**APPENDIX A AMENDMENT**  
**T198 LINE – STRUCTURE 29-30**  
**SOUTH BRANCH OF ASHUELOT RIVER AND STATE ACQUIRED**  
**RAILROAD PROPERTY**  
**TROY, NH**

1. The design and proposed construction of this crossing is shown on the attached PSNH Transmission Drawing entitled “LINE T198 (115 KV) CROSSING BETWEEN STR. 29 & 30, SOUTH BRANCH ASHUELOT RIVER, TROY, NEW HAMPSHIRE”.

THIS DRAWING REPLACES THE PREVIOUS DRAWING DATED 7/2008 AND CONTAINS UPDATED CABLE SAGS & CLEARANCES.

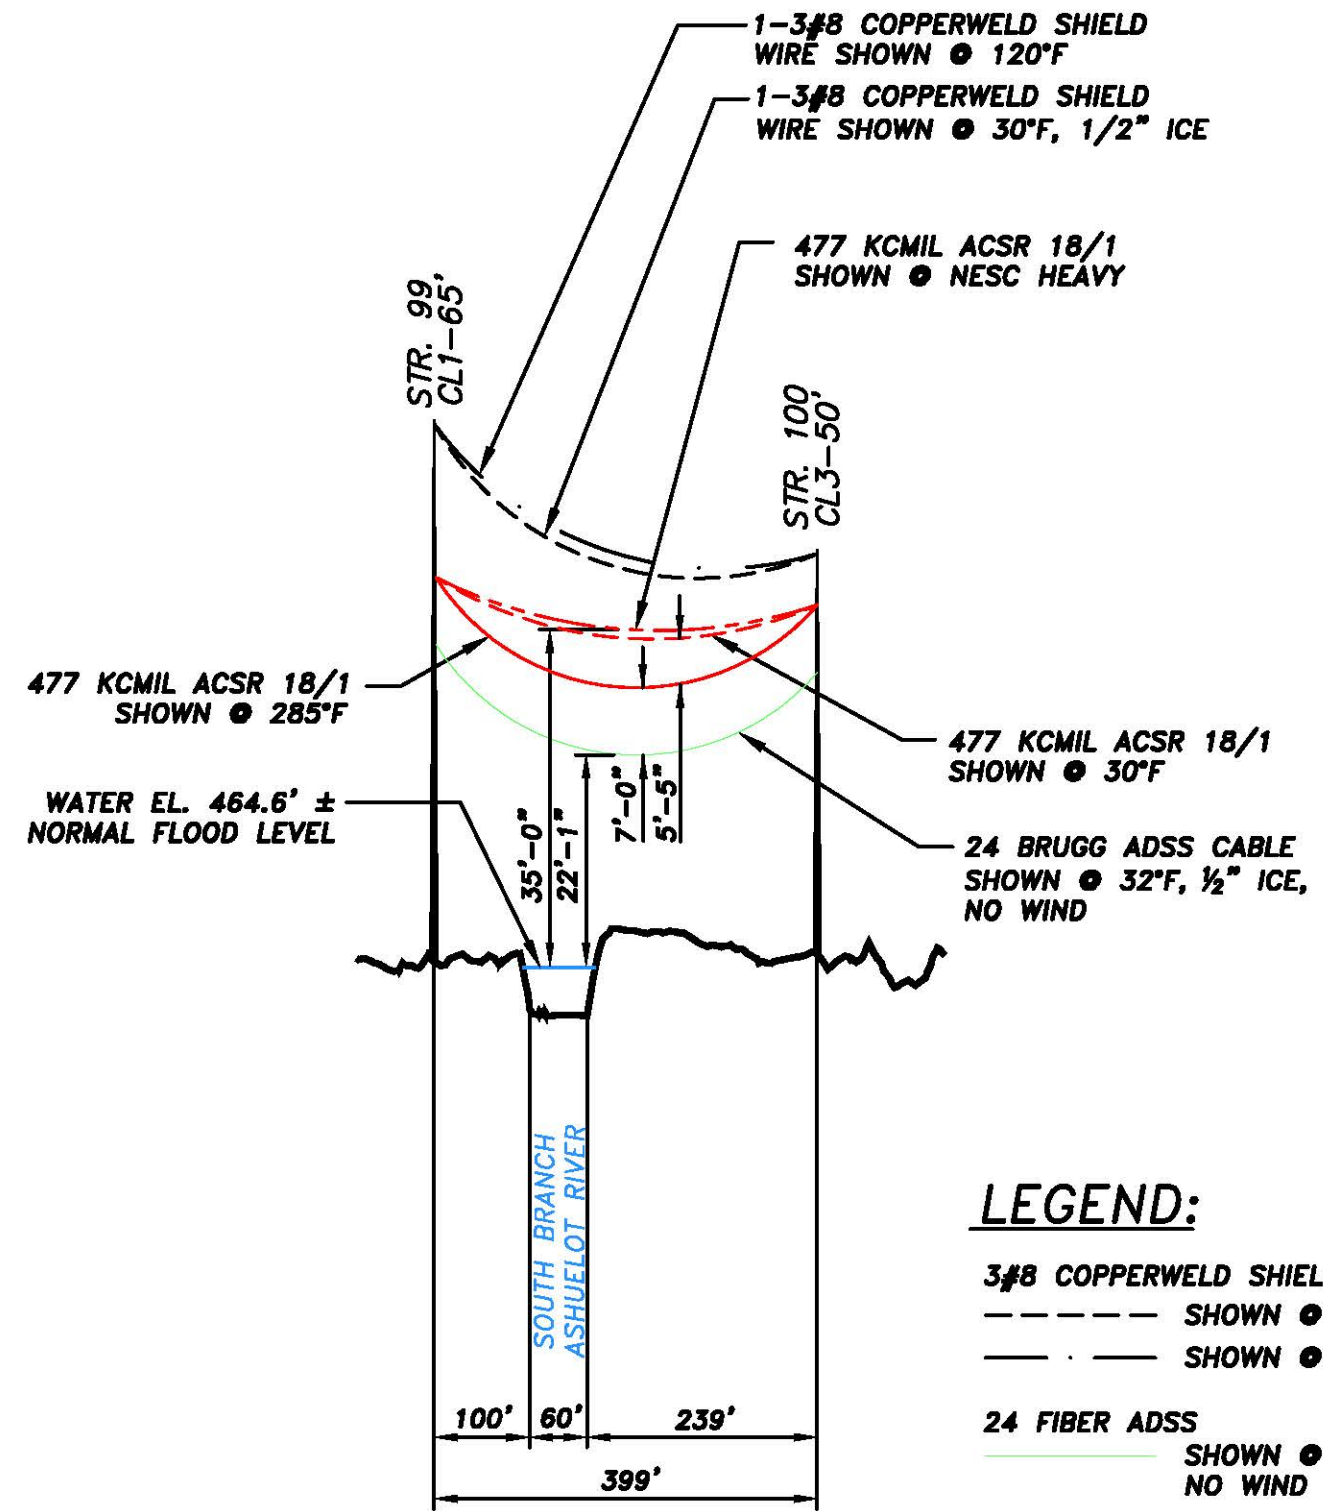
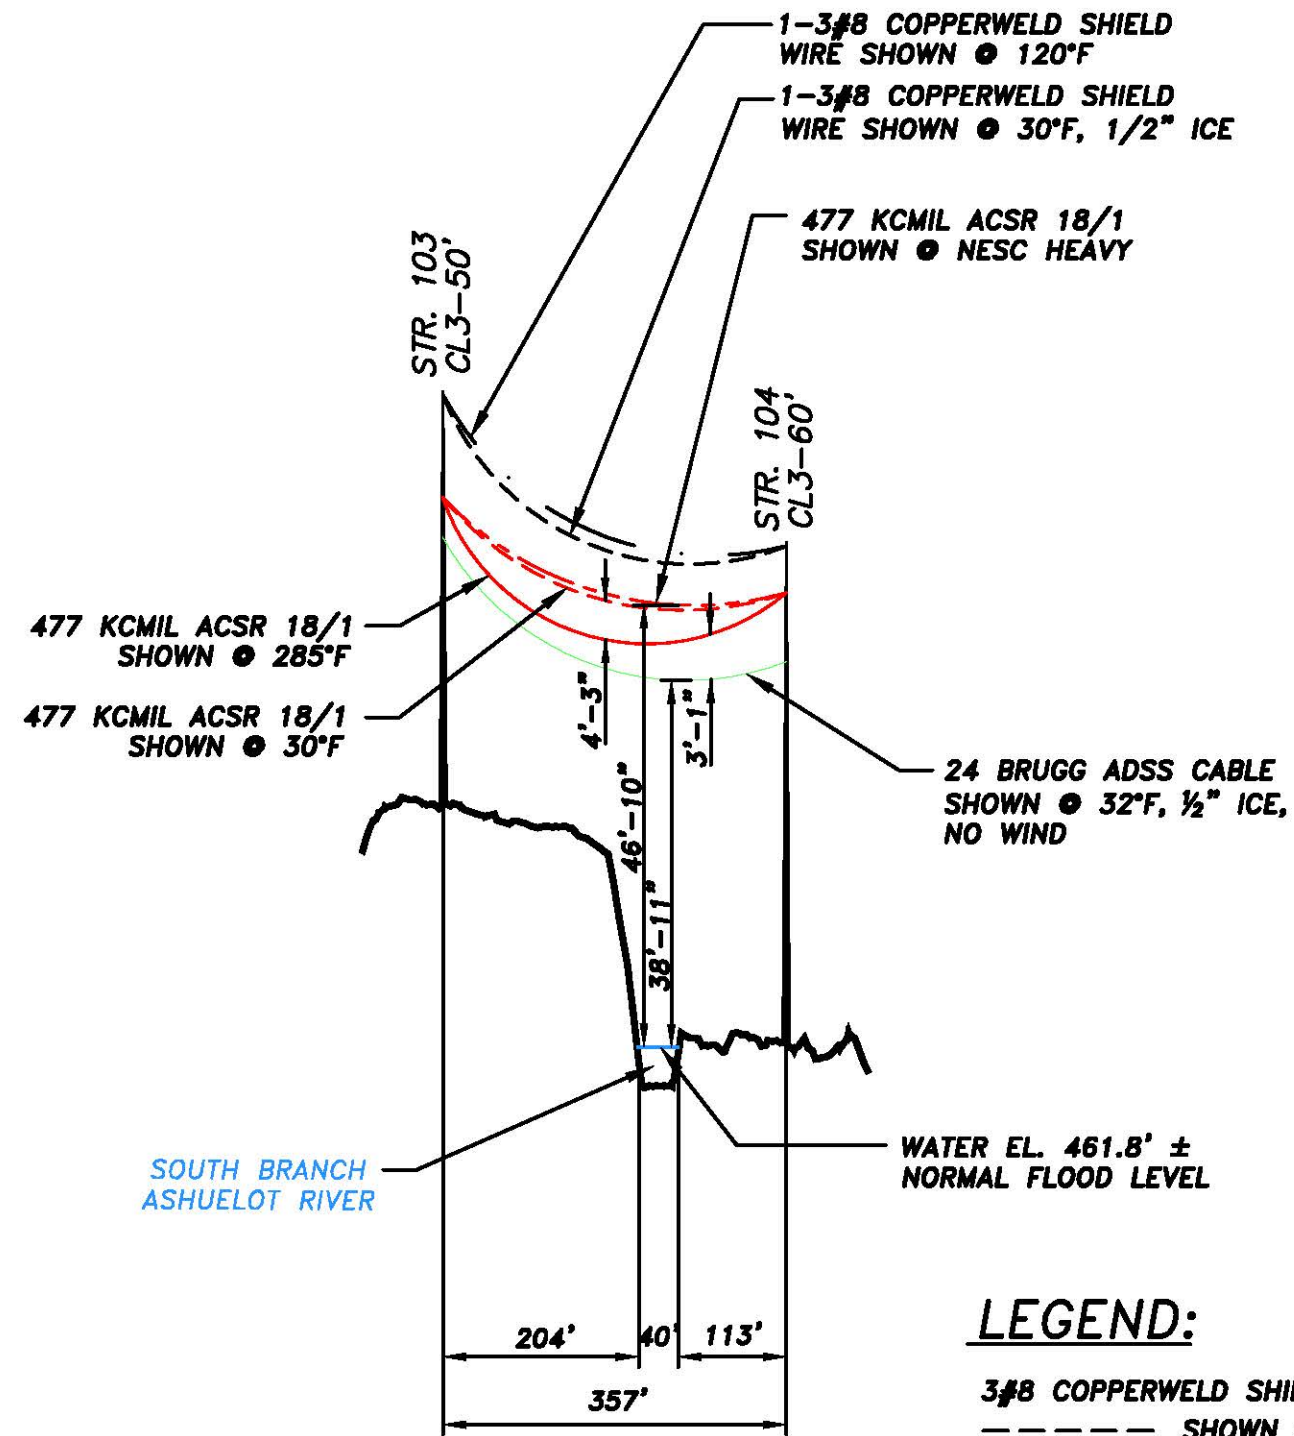
2. Currently, Line T198 crosses the South Branch Ashuelot River on an 65’ type DA structure (West) and a 50’ type A structure (East) with a span of 398.99 feet. Detailed drawings of these structures have been provided with his amendment. Minimum distances to ground for pedestrian traffic of 15.5 feet for the ADSS and 20.1 feet for the 115kV open supply per the NESC have been met as 15.1 and 21.4 feet of clearance is provided respectively for the ADSS and conductor wires.

6. As stated in the NESC (Table 232-1, Note 18), the surface area shall be enclosed by its high water mark and clearances hall be based on the normal flood level. In this case, the final river elevation at this location during the normal flood is 464.6 feet. The current sags and clearances to the water surface are as follows:

- Conductors (phase wires) – The maximum sag for the conductor will occur under the maximum operating condition (285 deg F). This condition produces the greatest sag and therefore the minimum clearance to water surface. At the time of the original petition, the clearance to water surface exceeded the minimum requirement of 22.1 feet with a clearance of 29.6 feet under temporary emergency conditions. The clearance to the water surface of the conductor, under the maximum operating condition, after thermal uprate will be 29.1 feet.

- ADSS cable – The maximum sag for the ADSS cable will occur under the weather case of 32 deg F; ½ inch radial ice; no wind and therefore produces the minimum clearance to the water surface. At the time of the original petition, the clearance to water surface exceeded the minimum requirement of 17.5 feet with a clearance of 22.1 feet

THIS DRAWING REPLACES THE PREVIOUS DRAWING DATED 7/2008 AND CONTAINS UPDATED CABLE SAGS & CLEARANCES.

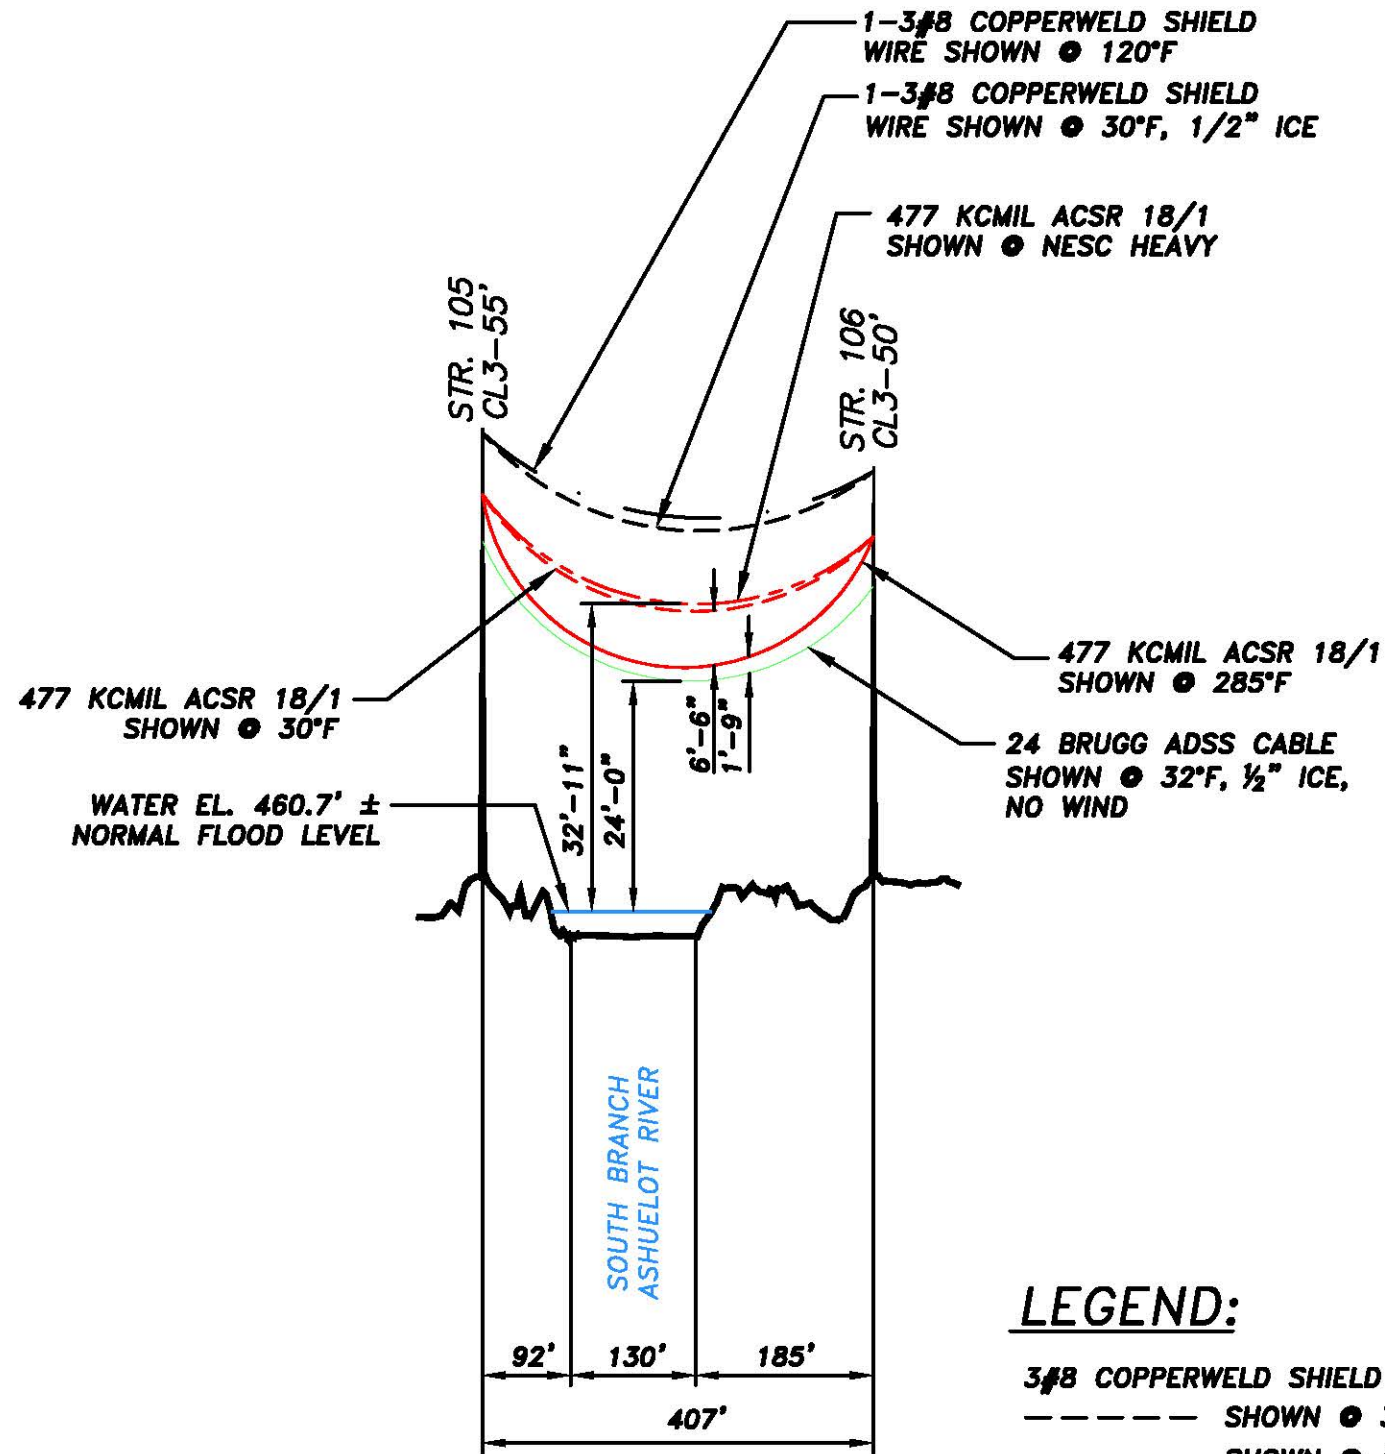
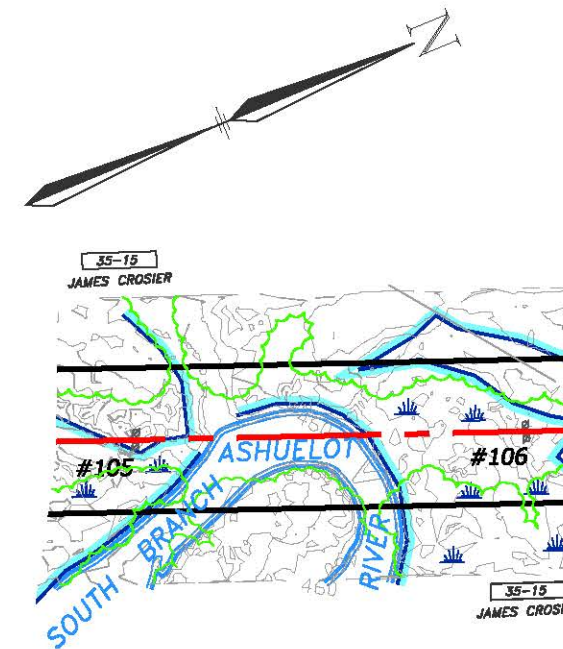
2. Currently, Line T198 crosses the South Branch Ashuelot River on a 50’ type A structure (West) and a 60’ type A structure (East) with a span of 357.47 feet. Detailed drawings of these structures have been provided with his amendment. Minimum distances to ground for pedestrian access of 9.5 feet for the ADSS and 16.1 feet for the 115kV open supply per the NESC have been met as 18.6 and 19.2 feet of clearance is provided respectively for the ADSS and conductor wires.

6. As stated in the NESC (Table 232-1, Note 18), the surface area shall be enclosed by its high water mark and clearances hall be based on the normal flood level. In this case, the final river elevation at this location during the normal flood is 461.8 feet. The current sags and clearances to the water surface are as follows:

- Conductors (phase wires) – The maximum sag for the conductor will occur under the maximum operating condition (285 deg F). This condition produces the greatest sag and therefore the minimum clearance to water surface. At the time of the original petition, the clearance to water surface exceeded the minimum requirement of 22.1 feet with a clearance of 41.1 feet under temporary emergency conditions. The clearance to the water surface of the conductor, under the maximum operating condition, after thermal uprate will be 42.0 feet.

- ADSS cable – The maximum sag for the ADSS cable will occur under the weather case of 32 deg F; ½ inch radial ice; no wind and therefore produces the minimum clearance to the water surface. At the time of the original petition, the clearance to water surface exceeded the minimum requirement of 17.5 feet with a clearance of 38.9 feet

THIS DRAWING REPLACES THE PREVIOUS DRAWING DATED 7/2008 AND CONTAINS UPDATED CABLE SAGS & CLEARANCES.

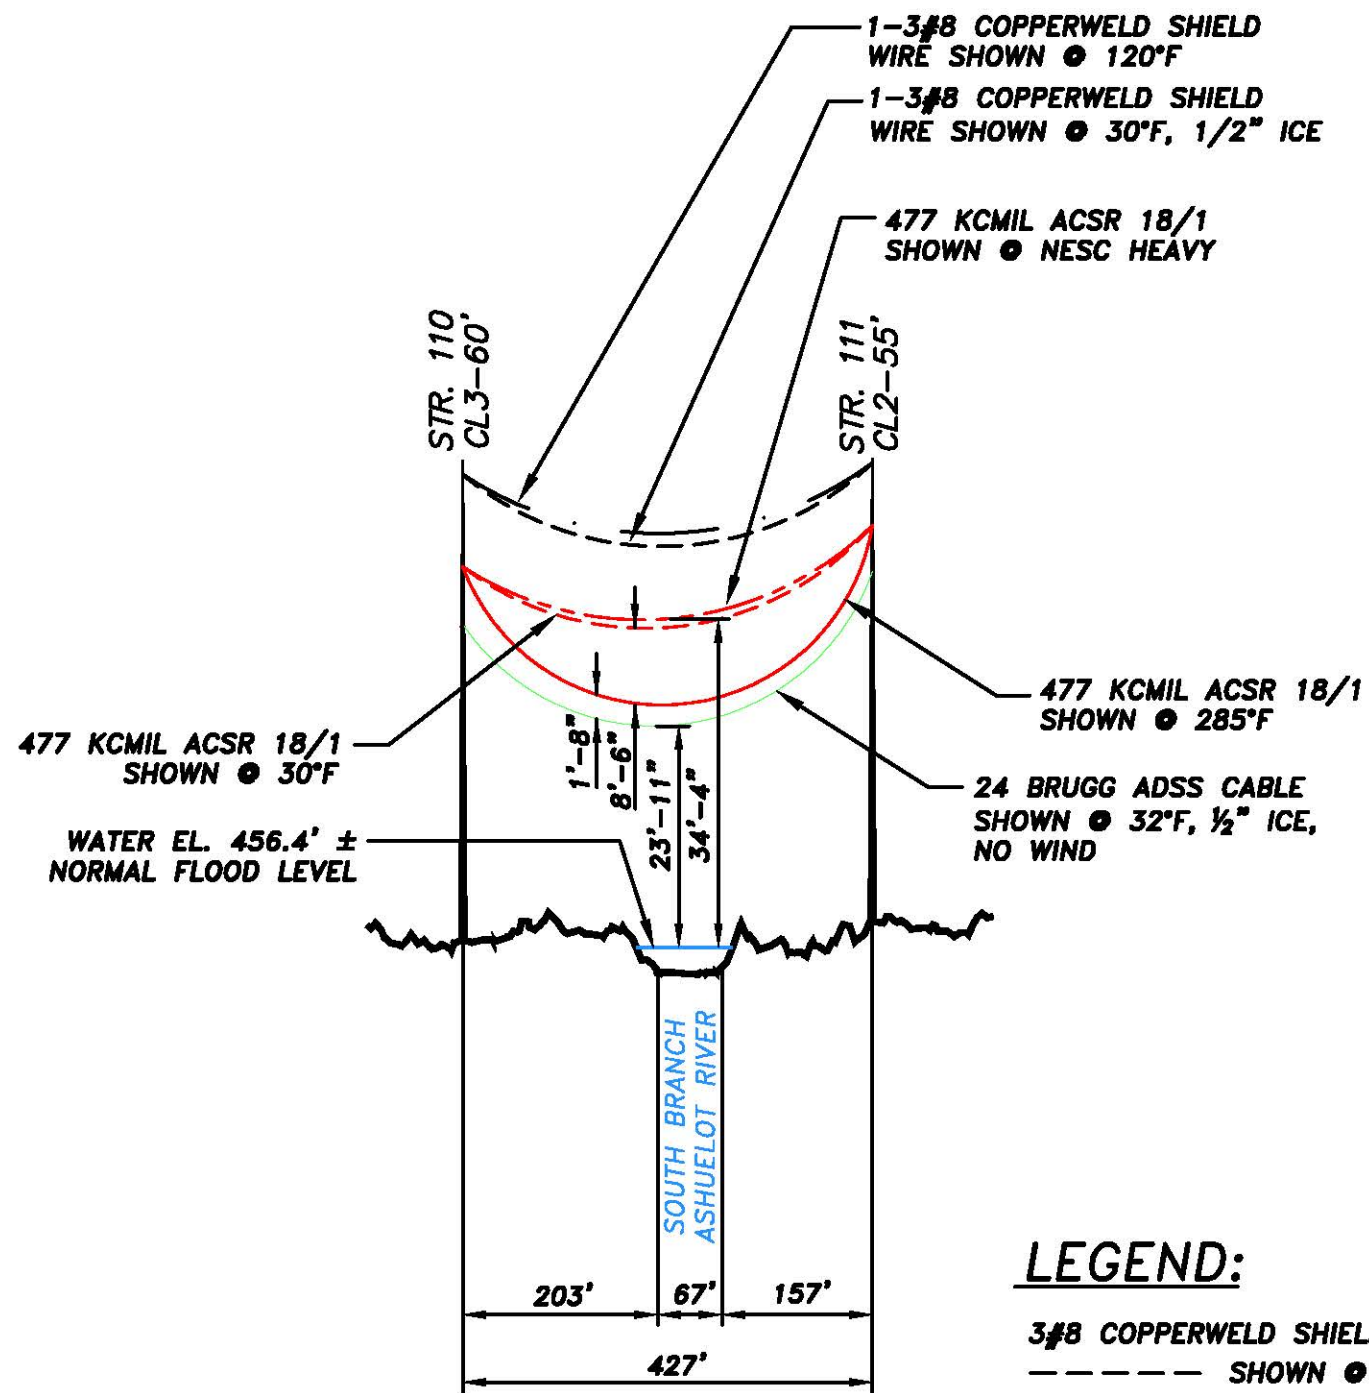
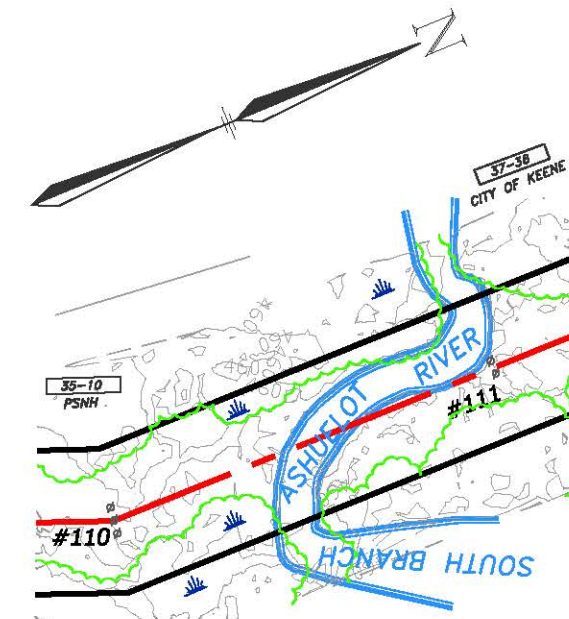
2. Currently, Line T198 crosses the Ashuelot River on a 55’ type A structure (West) and a 50’ type A structure (East) with a span of 407.20 feet. Detailed drawings of these structures have been provided with his amendment. Minimum distances to ground for truck traffic of 15.5 feet for the ADSS and 20.1 feet for the 115kV open supply per the NESC have been met as 19.4 and 20.7 feet of clearance is provided respectively for the ADSS and conductor wires.

6. As stated in the NESC (Table 232-1, Note 18), the surface area shall be enclosed by its high water mark and clearances hall be based on the normal flood level. In this case, the final river elevation at this location during the normal flood is 460.7 feet. The current sags and clearances to the water surface are as follows:

- Conductors (phase wires) – The maximum sag for the conductor will occur under the maximum operating condition (285 deg F). This condition produces the greatest sag and therefore the minimum clearance to water surface. At the time of the original petition, the clearance to water surface exceeded the minimum requirement of 22.1 feet with a clearance of 24.9 feet under temporary emergency conditions. The clearance to the water surface of the conductor, under the maximum operating condition, after thermal uprate will be 25.8 feet.

- ADSS cable – The maximum sag for the ADSS cable will occur under the weather case of 32 deg F; ½ inch radial ice; no wind and therefore produces the minimum clearance to the water surface. At the time of the original petition, the clearance to water surface exceeded the minimum requirement of 17.5 feet with a clearance of 24.0 feet.

THIS DRAWING REPLACES THE PREVIOUS DRAWING DATED 7/2008 AND CONTAINS UPDATED CABLE SAGS & CLEARANCES.
